Subject: College Park Elementary School HVAC Replacement
San Mateo - Foster City School District
Aedis Project No. 2021005.01
DSA Application #01-119530

ADDENDUM NO. 1

College Park Elementary School HVAC Replacement
San Mateo – Foster City School District
Aedis Project No. 2021005.01

2 ELECTRICAL SWITCHGEAR DIMENSIONS

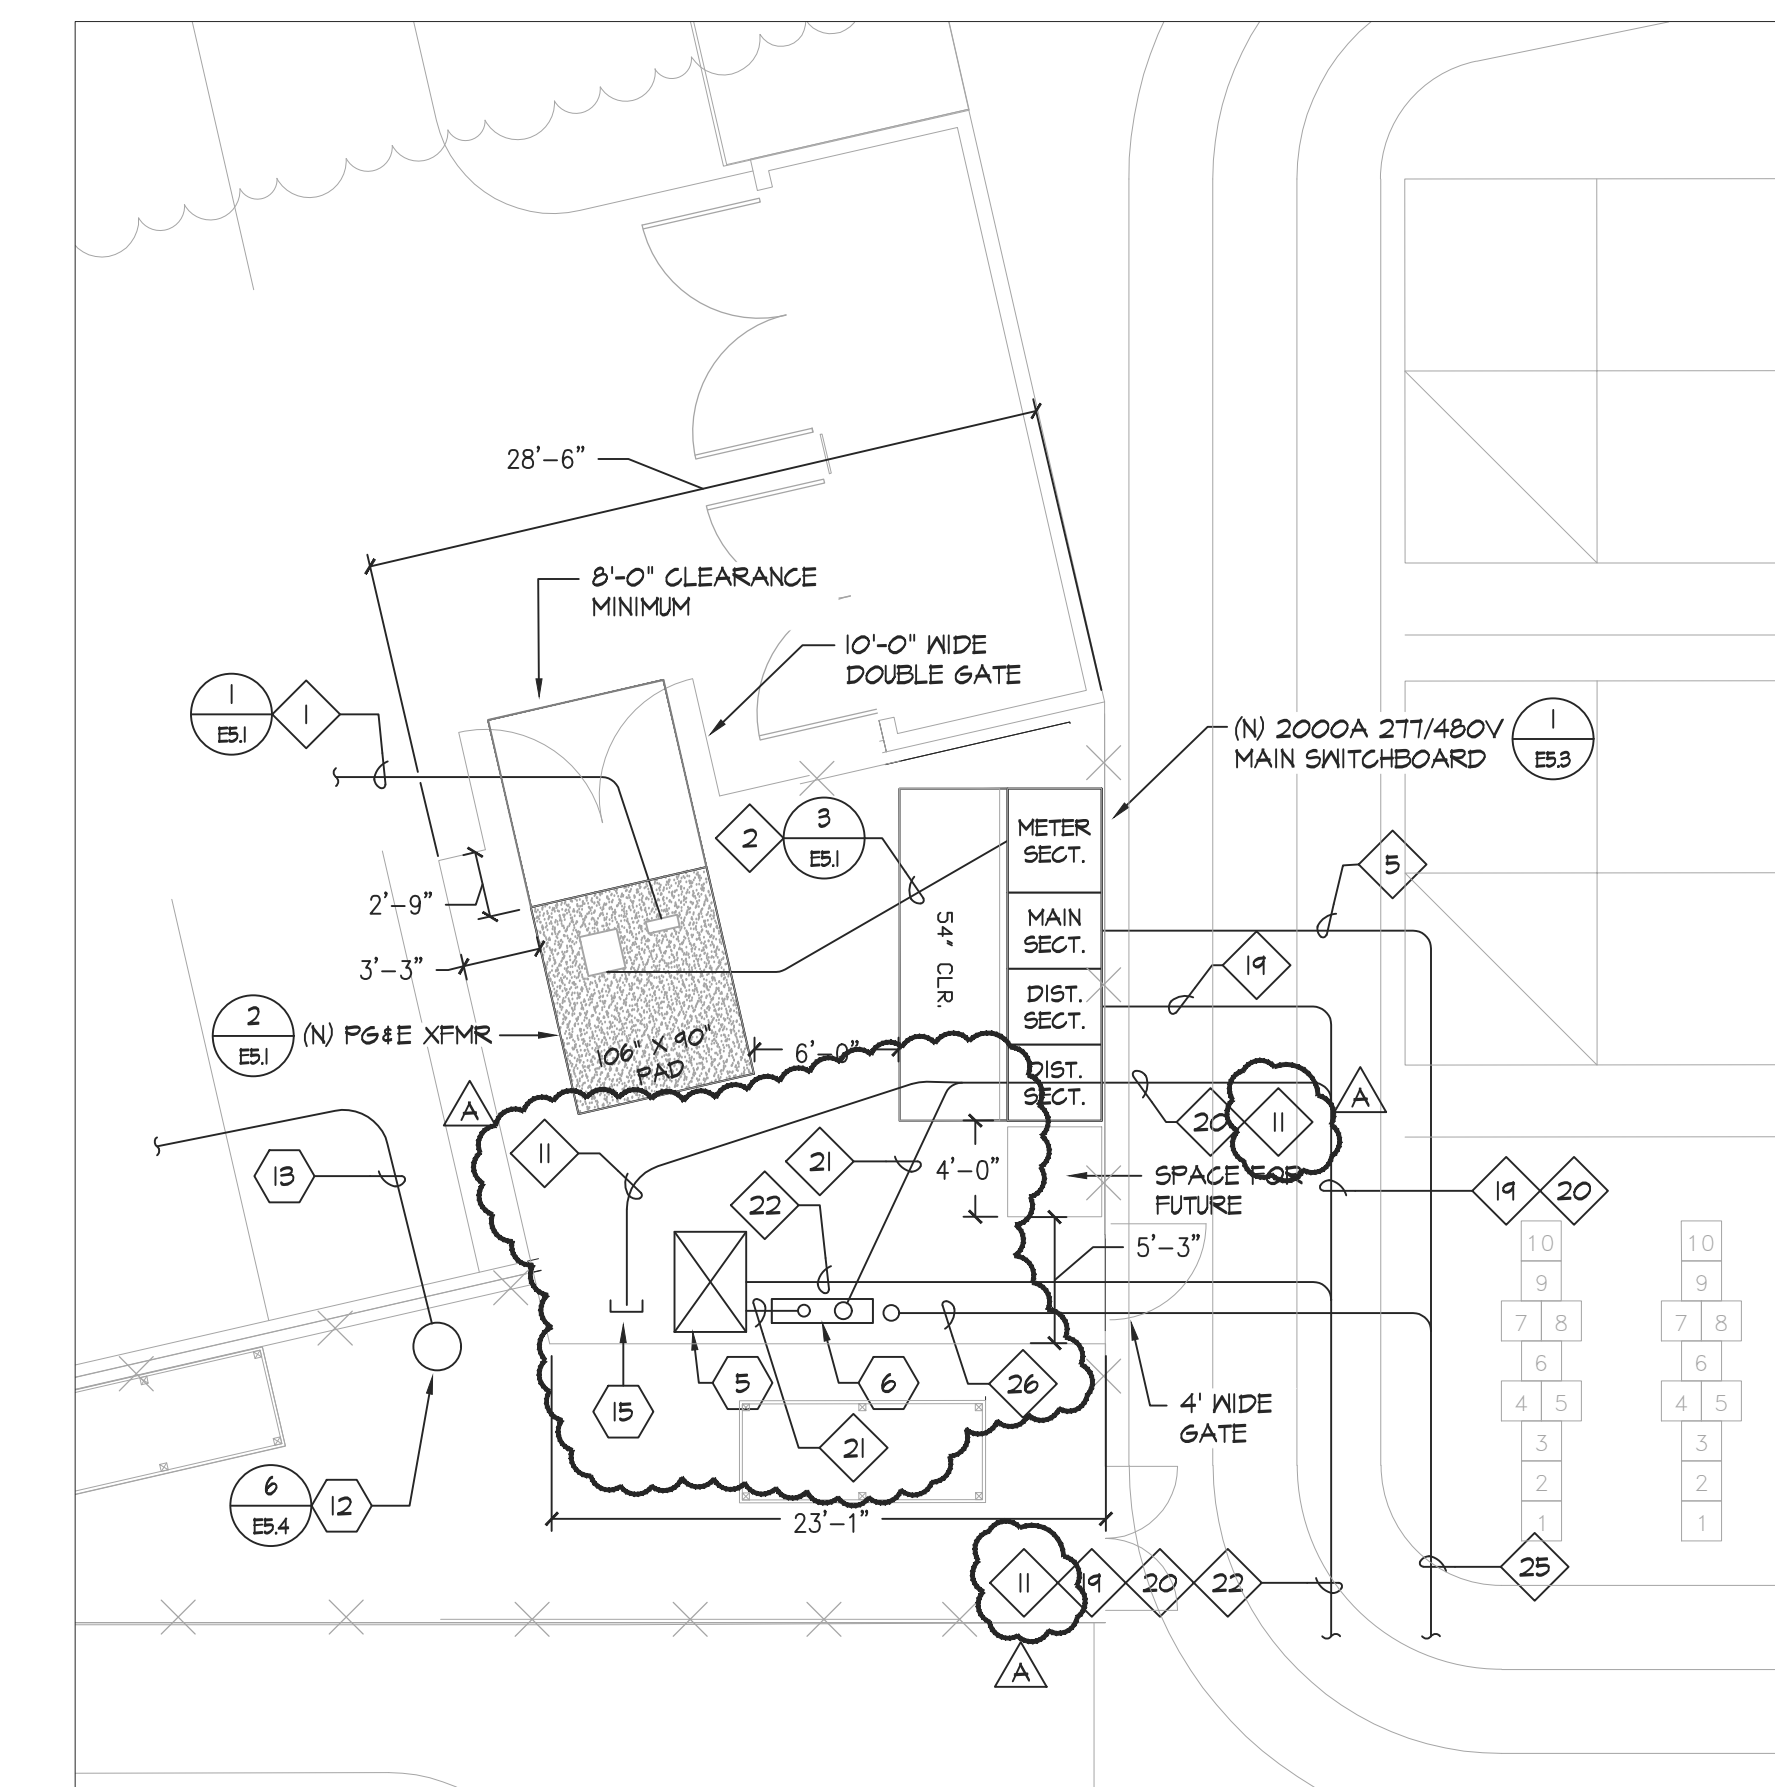
Revise: Conduit Schedule tag #11 per AD1-E1.1
Add: Sheet Notes #14, 15 per AD1-E1.1
Add: Underground EV conduit added at 2/E1.1 per AD1-E1.1

DATE 11/24/2021
JOB # 2021005.01
SHEET # AD-1
E3.1

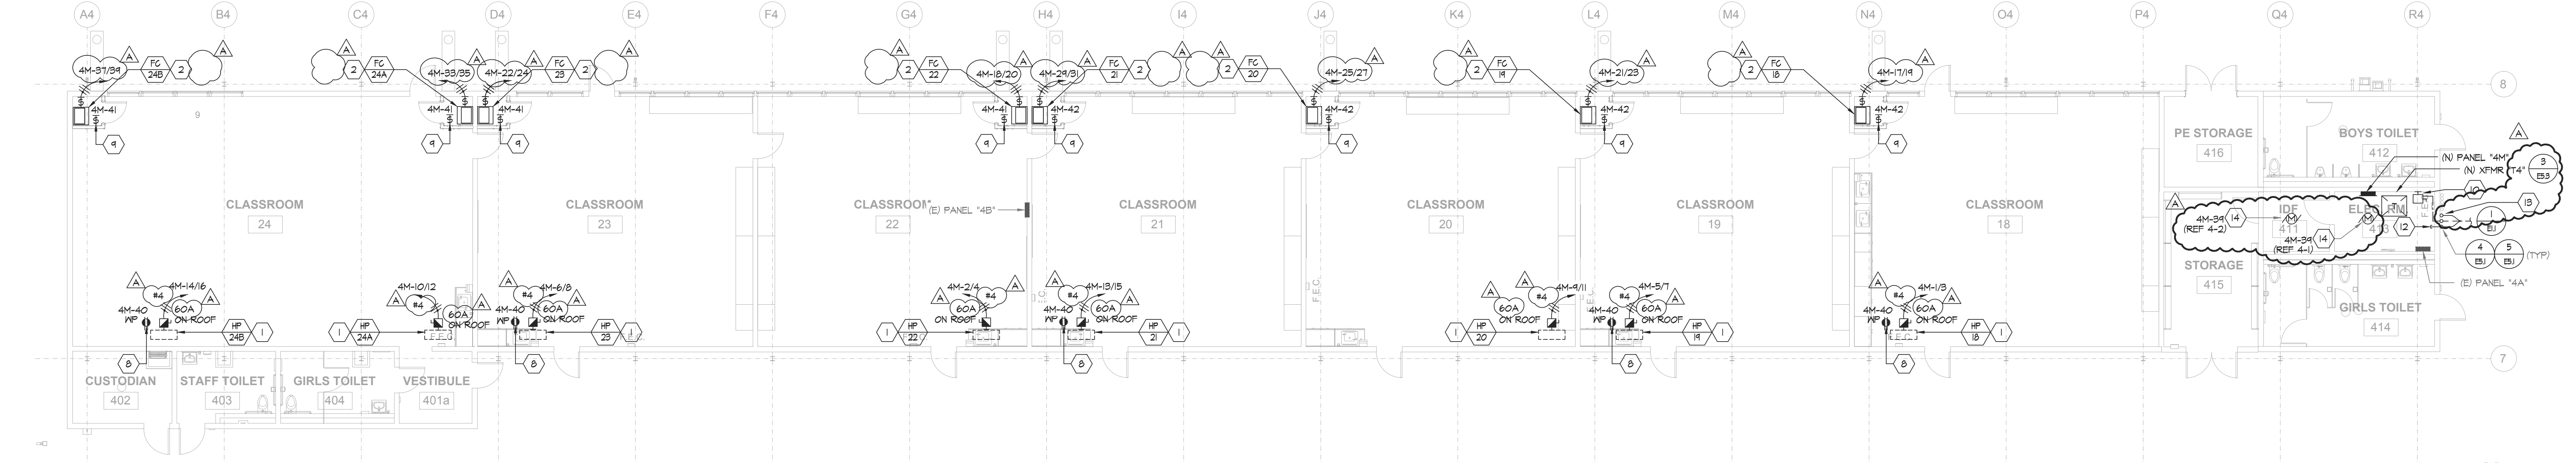
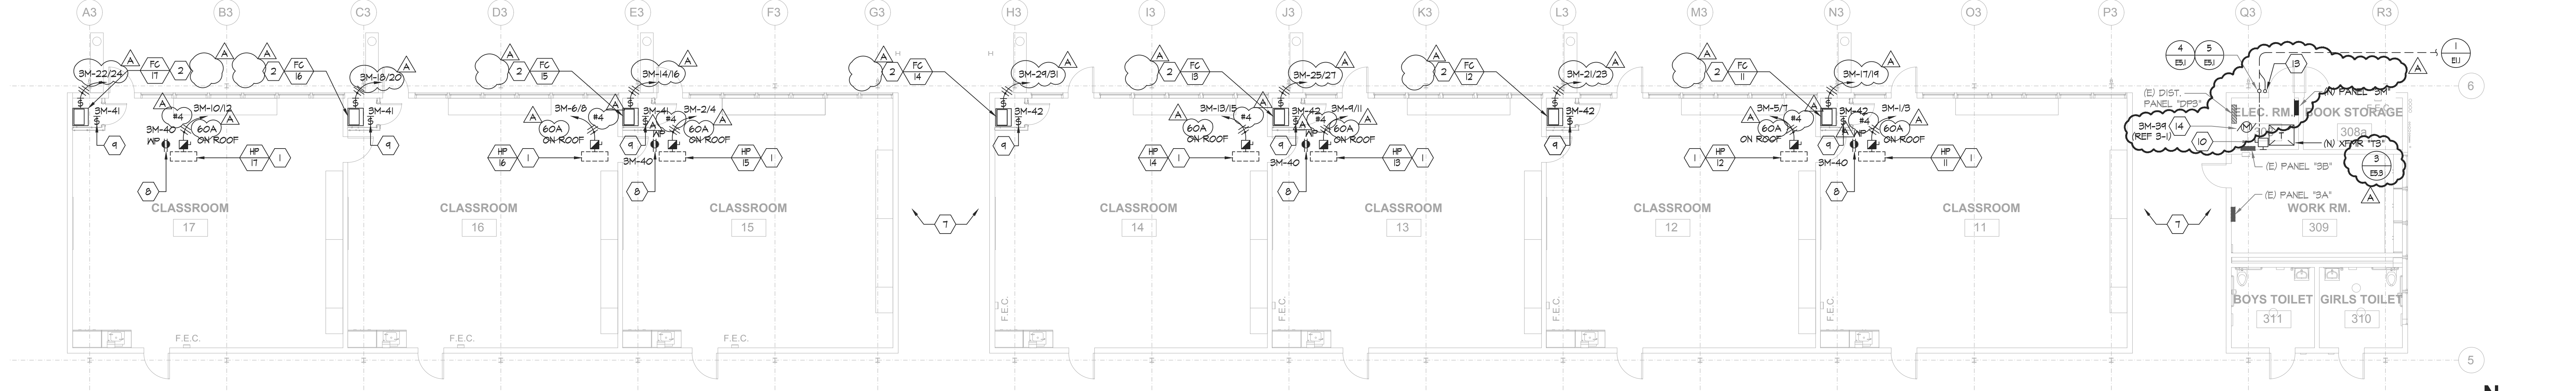
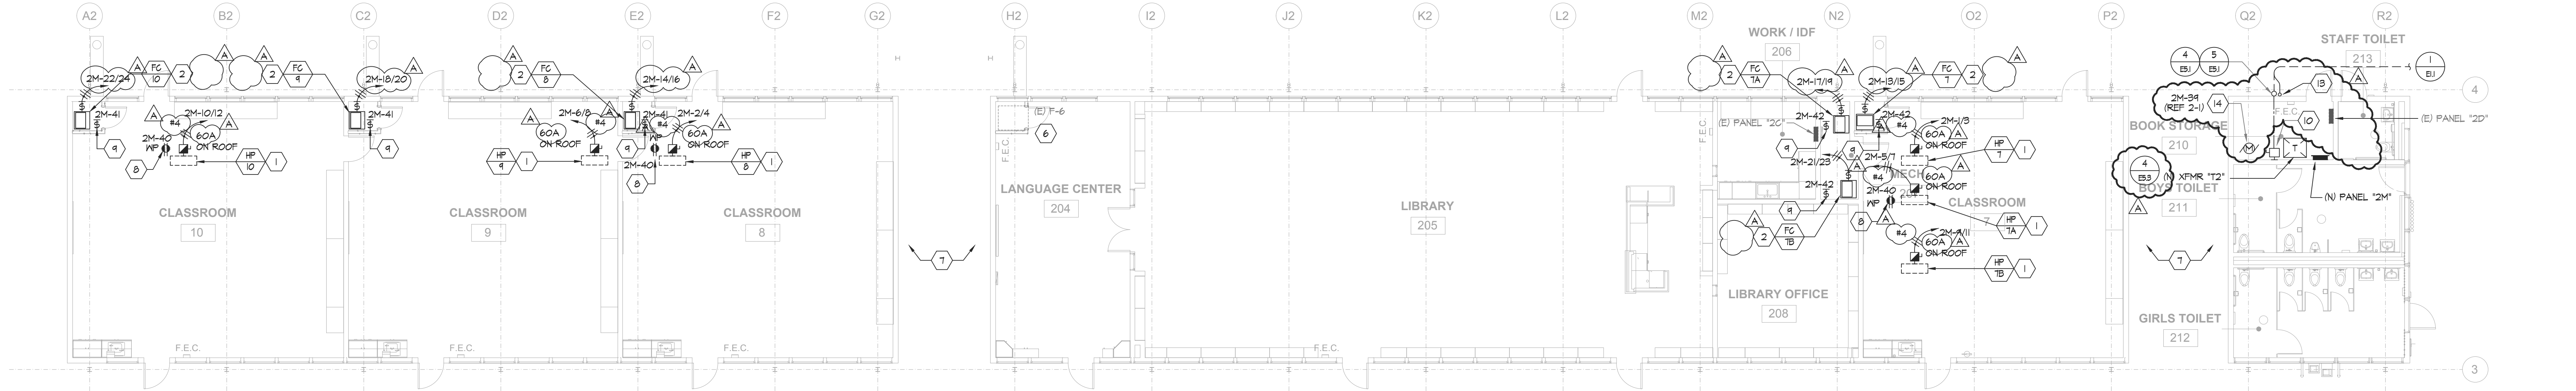
Add: Power for exhaust fan at each wing per AD1-E3.1
Add: Solar Conduit stub ups at each wing per AD1-E3.1
Revise: Electrical plan 1/E3.1, 2/E3.1 & 3/E3.1 per AD1-E3.1
Add: General Note #6 per AD1-E3.1
Revise: Sheet Notes #1, #2 & #4 per AD1-E3.1
Add: Sheet Notes 13 & 14 per AD1-E3.1

14 PROVIDE NEMA-3R, 120V MOTOR RATED SWITCH FOR ROOFTOP EXHAUST FAN. ROUTE 120V CIRCUIT TO THE PANEL AND CIRCUIT INDICATED. COORDINATE EXACT LOCATION WITH MECHANICAL CONTRACTOR.

DATE 11/24/2021
JOB # 2021005.01
SHEET # AD-1
E4.2

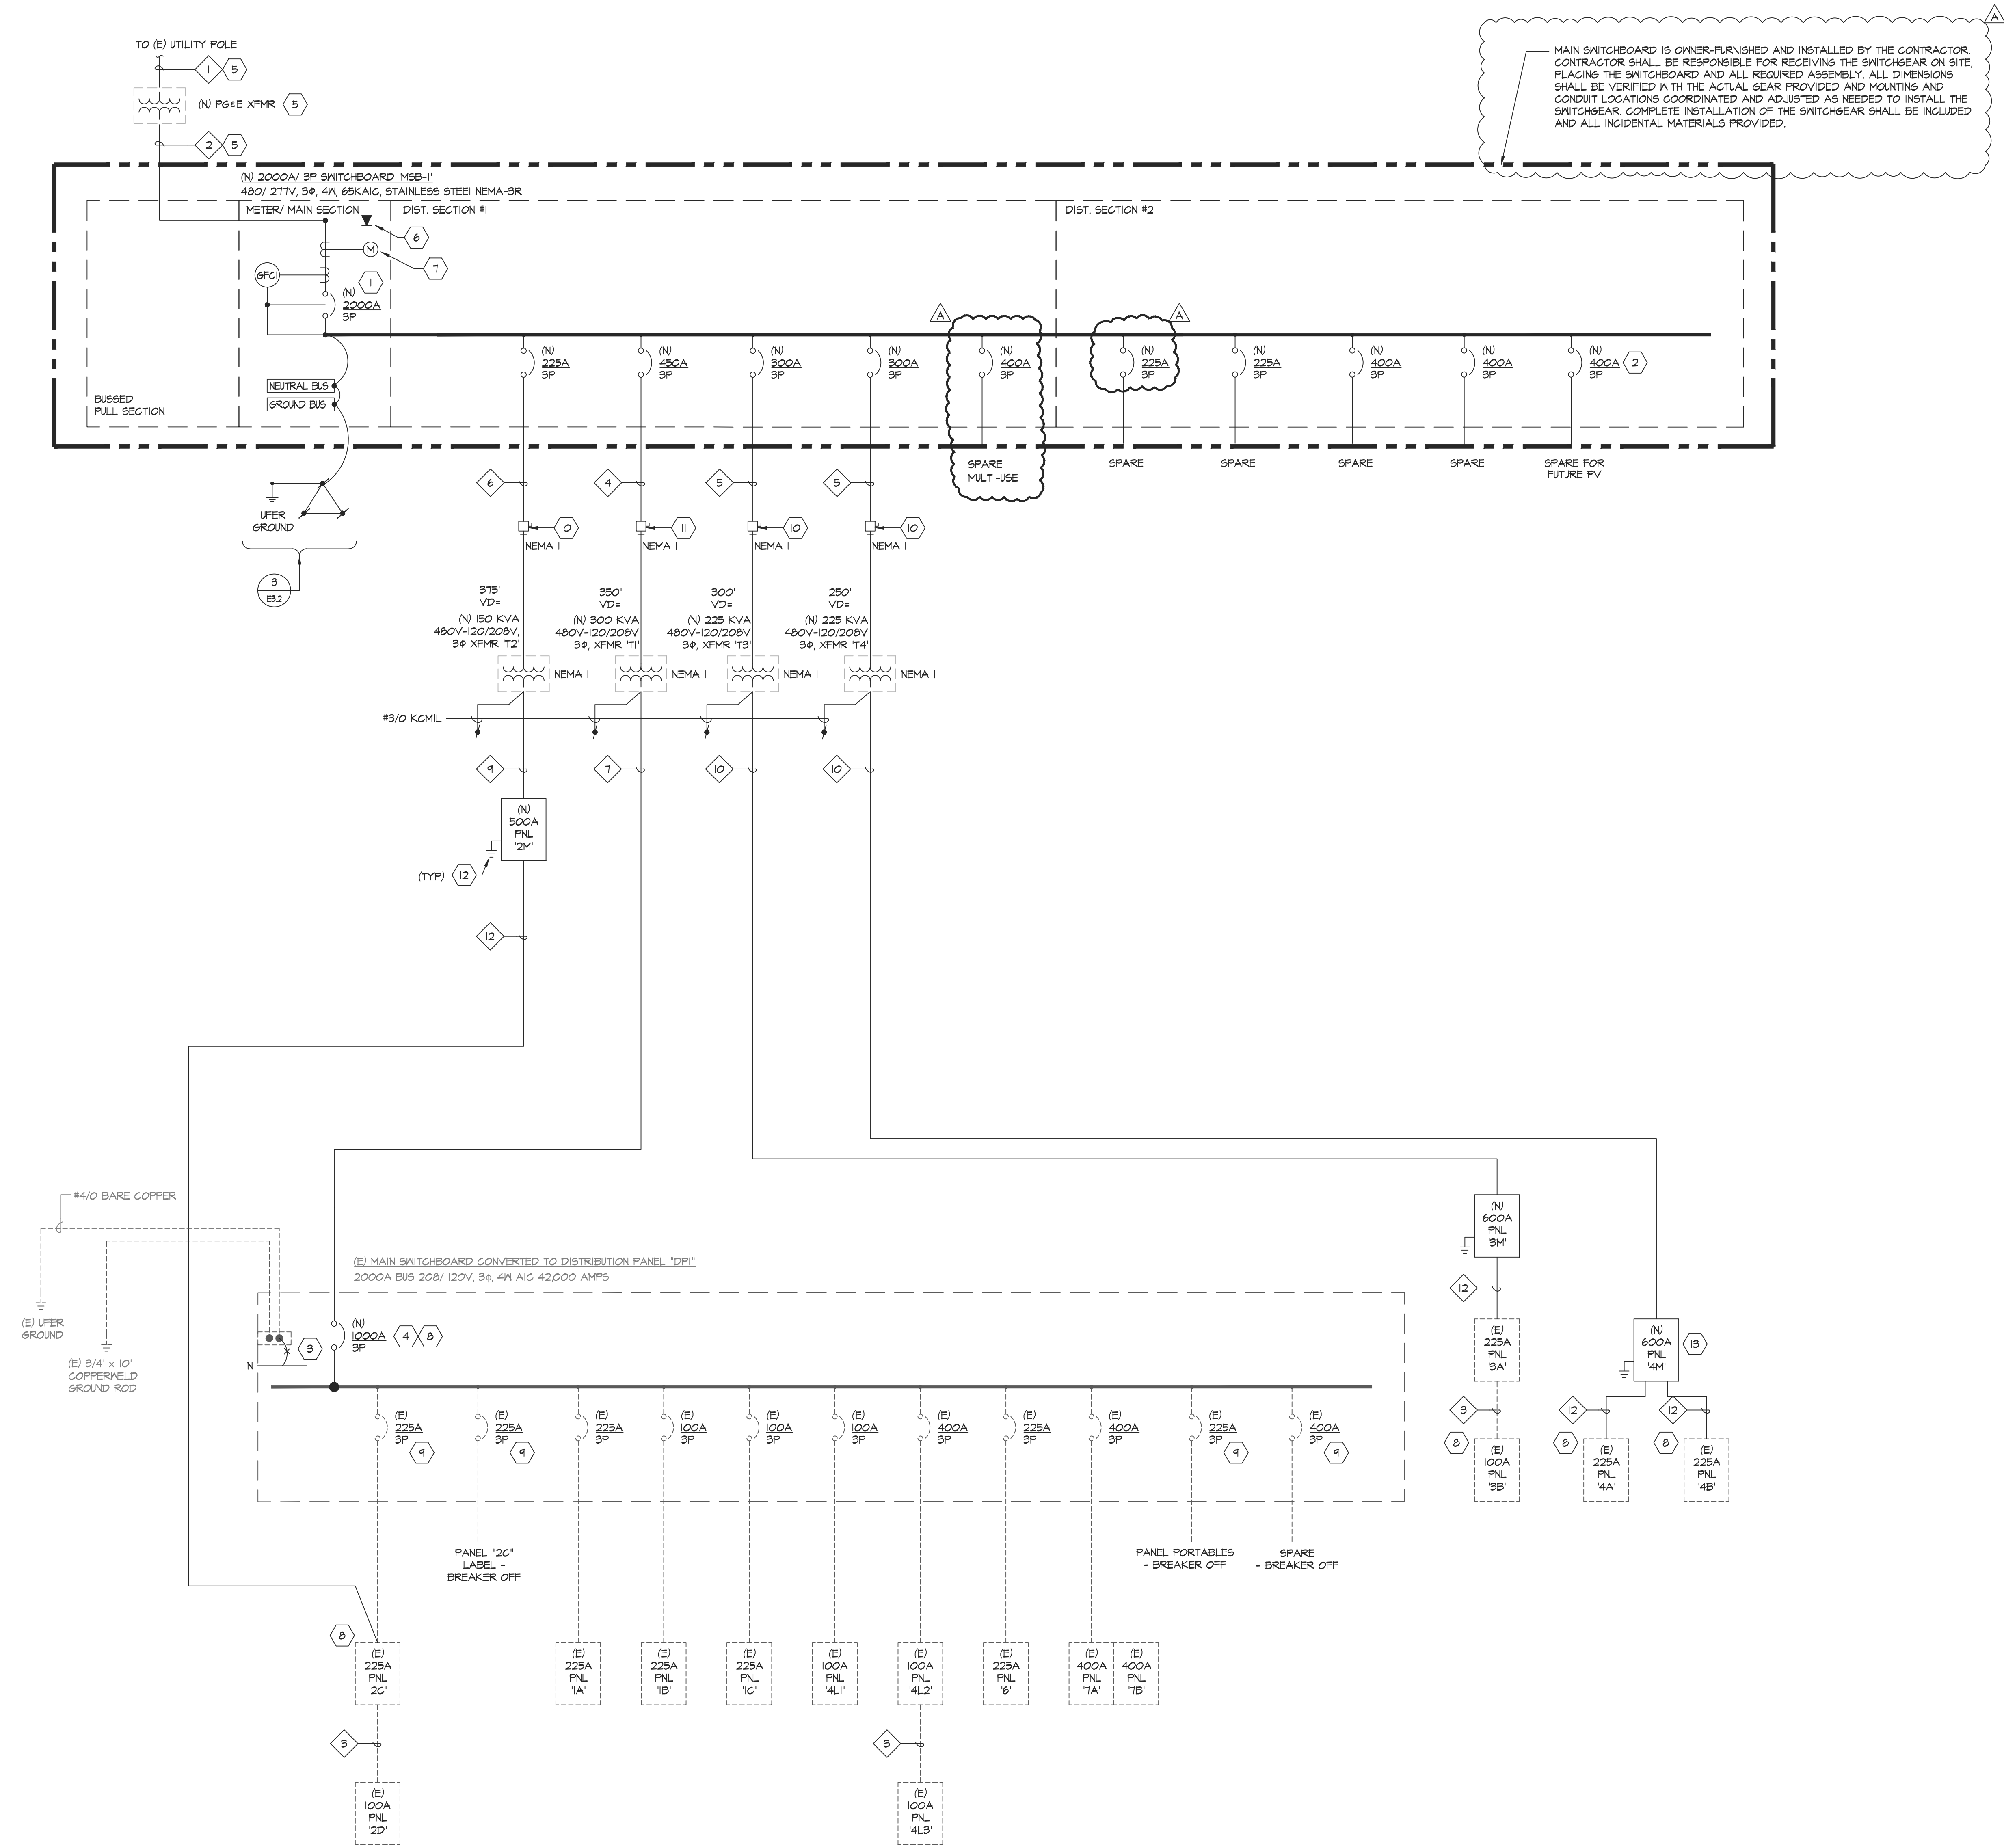
Revise: Circuit breakers at the switchgear per AD1-E4.2
Add: Switchboard to be OFCI per AD1-E4.2

- REMOVE EXISTING 2000A MAIN CIRCUIT BREAKER AND REPLACE WITH NEW 1000A MAIN CIRCUIT BREAKER AS REQUIRED TO CONVERT THE EXISTING MAIN SWITCHBOARD TO DISTRIBUTION PANEL (DPI). CONNECT NEW FEEDERS TO (DPI) AS REQUIRED.
